DEVELOPMENT ASSESSMENT REPORT	
Application No.	DA/2021/0776
Address	301-305 Liverpool Road ASHFIELD NSW 2131
Proposal	Construction of a mixed use development comprising of ground level commercial premises with a 67 room boarding house with managers residence over a single level of basement parking.
Date of Lodgement	26 August 2021
Applicant	Appwam Pty Ltd
Owner	Carlini Superannuation Pty Ltd & Appwam Pty Ltd
Number of Submissions	Initial: 7
Value of works	\$5,943,951.00
Reason for determination at Planning Panel	Clause 4.6 variation exceeds 10%
Main Issues	Affordable Housing, Height, FSR, Design, Parking, Amenity Impacts
Recommendation	Refusal
Attachment A	Reasons for refusal
Attachment B	Plans of proposed development
Attachment C	Clause 4.6 Exception to Development Standards
Attachment D	Draft conditions in the event of approval by Panel
Attachment E	Architectural Excellence Panel (AEP) Minutes

This report is an assessment of the application submitted to Council for the construction of a mixed use development comprising of ground level commercial premises with a 67 room boarding house and managers residence over a single level of basement parking at 301-305 Liverpool Road Ashfiel

Clause 4.6 - Request for Variation
 ALEP 2013 – Clause 4.4 Floor Space Ratio
 301-305 Liverpool Road, Ashfield

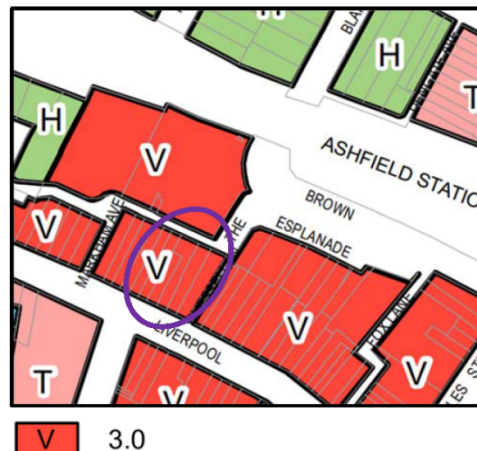
The subject site is mapped “V” – 03.0:1 (max).
